The Commission has issued the enclosed Amendment No. 42 to Facility Operating License No. DPR-43 for Kewaunee Nuclear Power Plant. The amendment consists of changes to the Technical Specifications in response to your applications transmitted by letters dated August 4, 1977, as subsequently revised on January 28, 1981, May 1, 1981, November 30, 1981 and February 1, 1982.

SAFETY EVALUATION BY THE OFFICE OF NUCLEAR REACTOR REGULATION
RELATED TO AMENDMENT NO. 42 TO FACILITY OPERATING LICENSE NO. DPR-43

DEGRADED GRID VOLTAGE PROTECTION
FOR THE CLASS IE SYSTEMS

ADEQUACY OF STATION ELECTRIC DISTRIBUTION
SYSTEM VOLTAGES

KEWAUNEE
UNIT ONE LINE DIAGRAM
FIGURE 1

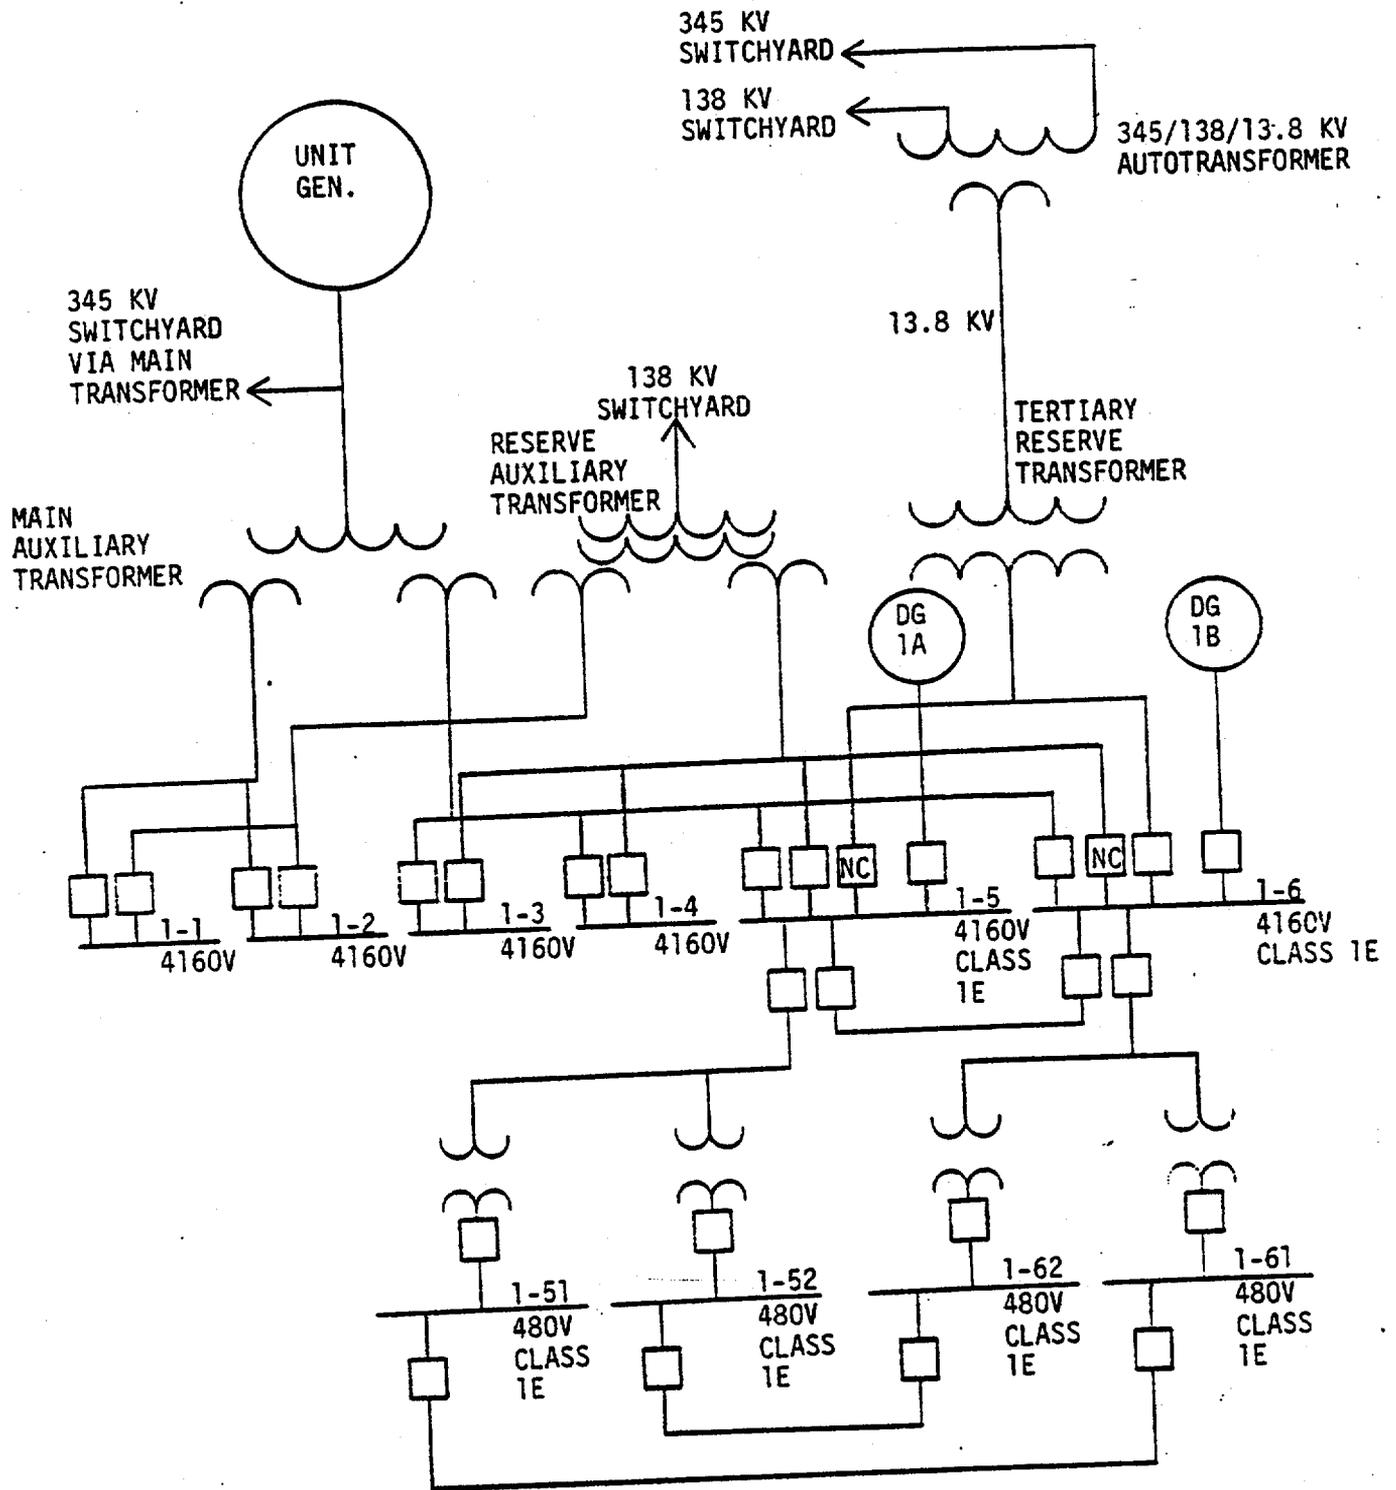
Figure 1 is a simplified sketch of the unit one-line diagram taken from Figure 8.2-2 of the Kewaunee Final Safety Analysis Report (FSAR). It shows that the 4160V Class 1E buses can be supplied offsite power by either the Reserve Auxillary Transformer (RAT) or the Tertiary Reserve Transformer (TAT). Additionally, there is a tie between buses 1-5 and 1-6. This bus tie is controlled by interlocks and administrative procedures, and is used only when all power sources to a bus, including the diesel-generator, are lost³.

Buses 1-5 and 1-6 each supply power to two 480V Class 1E buses by separate transformers. Buses 1-51 and 1-61 can also be connected together, as can buses 1-52 and 1-62. However, technical specifications 3.7.a.4 and 3.7.a.5 prevent use of the 480V bus ties during operation.

FSAR Figure 8.2-3 shows that the 120V instrument buses that use inverters for their normal power source can be powered, as an alternate source, from instrument transformers by Class 1E buses 1-52 and 1-62. These instrument transformers normally supply one independent 120V AC instrument bus.
